VBX and FORGE Hopper Spreader Gearbox Oil

SERVICE BULLETIN – MANDATORY REWORK

Figure 2

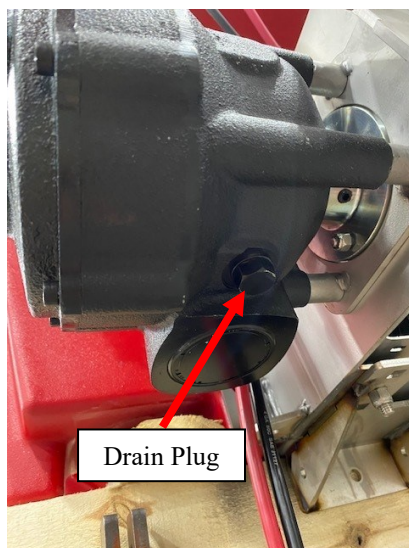
1. Ensure vehicle is parked on level ground and spreader is unplugged.
2. Remove the front cover of the spreader to access the gearbox.
3. Place a drain pan under the bottom drain plug of the gearbox, remove the drain plug and the fill plug to allow adequate draining of oil. (See Figures 2 and 3)
4. Drain the oil for at least 3 minutes or until oil is slowly dripping.
5. Reinstall the bottom drain plug.
6. Fill the gearbox with the specified oil until the oil level appears in the center of the sight window, approximately .8 L. (See Figure 4)
7. Reinstall the fill plug.
8. Reinstall the front cover of the spreader.
